Access Compliance Report Public Rights-of-Way (Curb Ramps)

Main Street: ESENCIA_DR Cross Street: CHIQUITA_CANYON_DR Location: N

ADA ID: RPRK211124133726 Ramp Type: Type 1 - Perpendicular Diagonal Initial Pass/Fail: Fail Overall Compliance: No Severity Score: 16

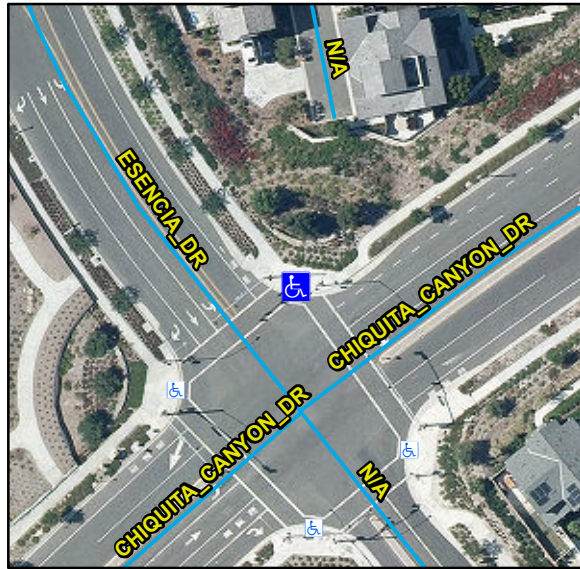
R304.2.2, R304.5.3, STD 1115

Remove & Replace Curb Ramp With Two New Directional Ramps or Equivalent.
